CONTRACT CHANGE ORDER NO. _____
 SHEET _____ OF _____

MARK	DATE	DESCRIPTIONS	BY	CH'D	CCO#
△	05/09/12	SADDLE BLOCKING	GB	MN	240
△	09/01/11	EAST END OBG	GB	MN	87

BRIDGE NO.	34-0006L/R
KILOMETER POST	13.2/13.9
EAST SADDLE DETAILS NO.3

**ELEVATION OF TYPICAL EAST SADDLE
 (IN THE PLANE OF CABLE)** (See Note 6)
 1:20

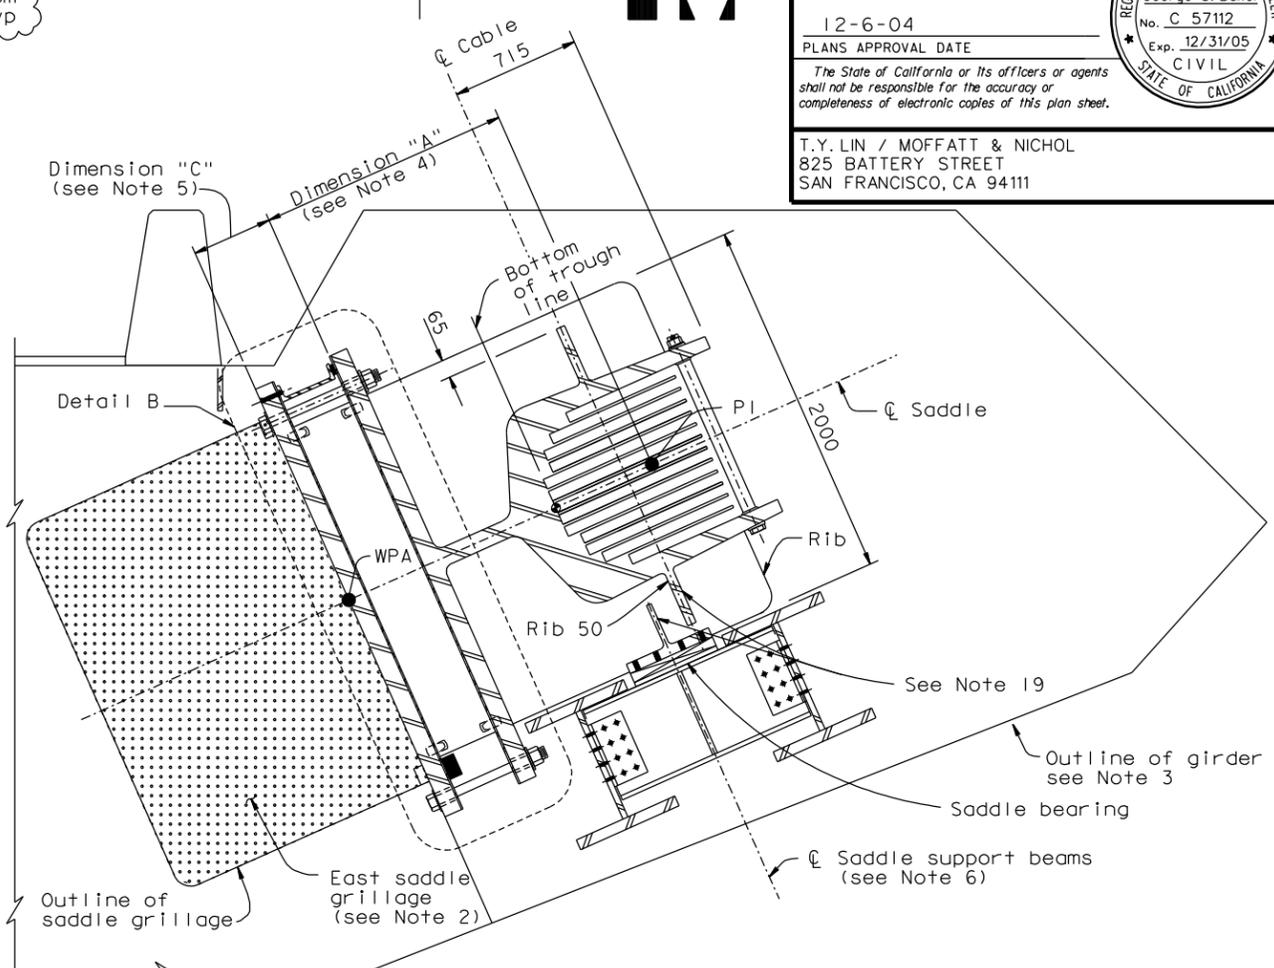
- 20. At the Contractor's option, it is acceptable to incorporate permanent diaphragm plates at the end splay plate, subject to review and approval of the Engineer.
- 21. The Contractor shall fabricate and install new blocking. For typical blocking, see Section A-A on "East Saddle Details No.5" sheet. For typical blocking details, see "East Saddle Details No.5A" sheet.
- 22. The blocking shall be placed such that it straddles the divider plate splicing joint.
